# National Transportation Safety Board

## Safety Recommendation

**In reply refer to:** A-03-07 through -10

On May 25, 2002, China Airlines flight CI-611, a Boeing 747-200 (B18255), crashed in the Taiwan Straits near the northern end of the Penghu Islands, Taiwan. Radar data indicate that the airplane experienced an in-flight structural breakup at about 35,000 feet. The airplane was on a scheduled passenger flight from Chiang Kai Shek International Airport, Taipei, Taiwan, to Chek Lap Kok Airport (Hong Kong International Airport), Hong Kong, China. All 225 occupants were killed.

**Figure 1.** Detail of the China Airlines 747-200 repair doubler  
(View looking up at bottom of aft fuselage)

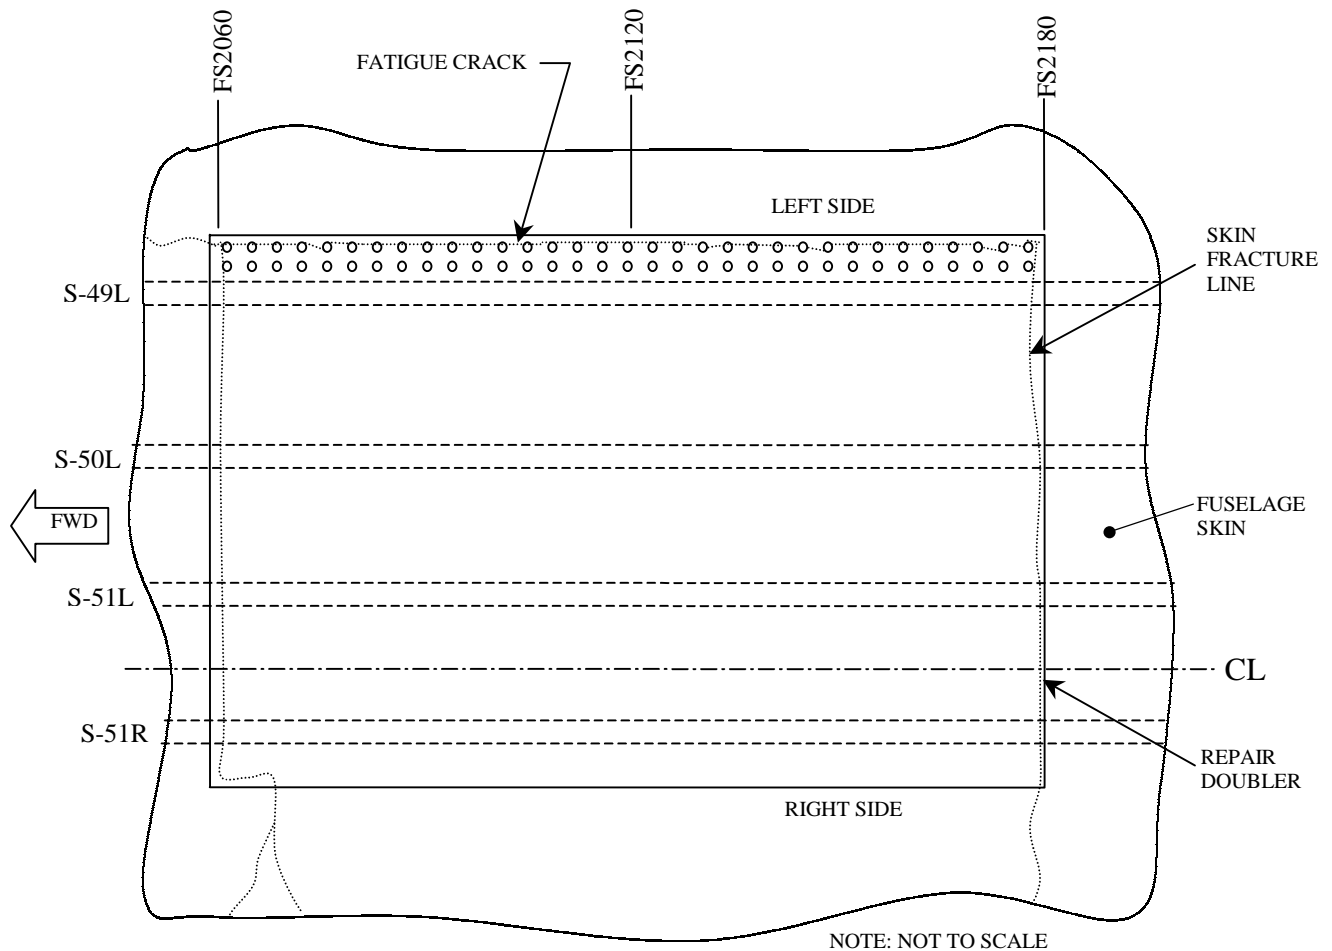
The recovered wreckage from the accident airplane included the repair doubler installed between FS 2060 and 2180. The doubler, which was about 120 inches long, 22 inches wide, and 0.100 inch thick, was installed over the original fuselage belly skin between stringers S-49L and S-51R. Although, as noted above, maintenance records indicate that the repair was conducted in accordance with the Boeing SRM, several discrepancies were noted. Specifically, the Boeing SRM required that the damaged skin be removed before installation of the doubler. However, the damaged skin was not removed; the fuselage skin underneath the doubler exhibited severe longitudinal scratching. Some of the scratching was located just outside the left perimeter of the repair rivets but was still hidden under the outer edge of the doubler. Further, most of the rivets attaching the doubler to the fuselage skin were overdriven, and some of the parts used in the repair did not meet the applicable material specifications.

Metallurgical examination of the recovered wreckage revealed a region of fatigue cracking with multiple-site fatigue damage (MSD)<sup>2</sup> extending for about 93 inches under the left edge of the doubler; the fatigue cracks in this region originated at the unremoved scratching just outside of the rivet line and propagated completely through the thickness of the skin in many areas within the fatigue region (see figure 1).<sup>3</sup> The fatigue region also contained individual fatigue cracks that were linked by quasi-stable crack growth, resulting in a single 93-inch-long crack. Almost all<sup>4</sup> of the fatigue cracking was located underneath the doubler and would not have been visible from the exterior of the airplane.
